Access Compliance Report

Public Rights-of-Way

Intersection ID: 27788	Main Street: PROVIDENCE_RD	Cross Street: PROVIDENCE_COUNTRY_CLUB_DR	Location: NW
ADA ID: BBF2F6BB5E27	Ramp Type: BlendTrans1	Initial Pass/Fail: Pass	Overall Compliance: No
		Severity Score: 0.25

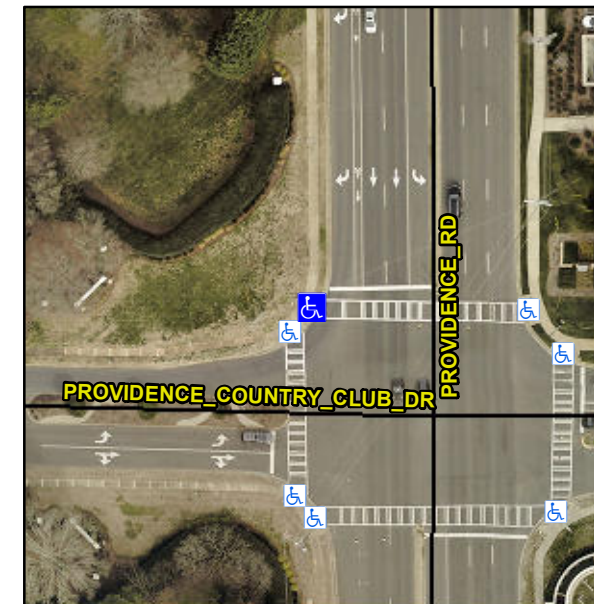
R304.5.3, R304.2.2-Perp, R304.3.2-Para, R305.2

Compliance	Description	Data	Compliance	Description	Data
N/A	Ramp Length (in)	49.0	Yes	BlendTrans Slope (%)	4.2
Yes	Ramp Width (in)	58.0	No	BlendTrans XSlope (%)	4.3
N/A	Flare Type LT	Sloped	N/A	Flare Type RT	Sloped
Yes	Flare Slope LT (%)	1.5	N/A	Flare Slope RT (%)	10.6
N/A	Flare Traversable LT?	Yes	N/A	Flare Traversable RT?	No
Yes	Landing Length (in)	59.0	Yes	DWS Provided?	Yes
Yes	Landing Width (in)	54.0	Yes	DWS Contrast?	Yes
No	Landing Slope (%)	3.0	Yes	DWS Length (in)	25.0
No	Landing X Slope (%)	5.1	Yes	DWS Full Width?	Yes
N/A	Landing Curb? (Y/N)	No	No	DWS Offset (in)	4.0
N/A	Shared Landing?	No			
Yes	Gutter Ponding?	No	Yes	Gutter Slope (%)	4.1
Yes	Gutter Lip Ht (in)	0.0	No	Gutter X Slope (%)	4.0
N/A	Painted X Walk1?	Yes	N/A	Painted X Walk2?	N/A
	X Walk 1 Direction	To E		X Walk 2 Direction	N/A
	X Walk 1 Width (in)	105.0		X Walk 2 Width (in)	N/A
	X Walk 1 Slope (%)	2.1		X Walk 2 Slope (%)	N/A
	X Walk 1 X Slope (%)	0.5		X Walk 2 X Slope (%)	N/A

Remove & Replace Curb Ramp With Two New Directional Ramps or Equivalent. Remove & Replace Gutter.
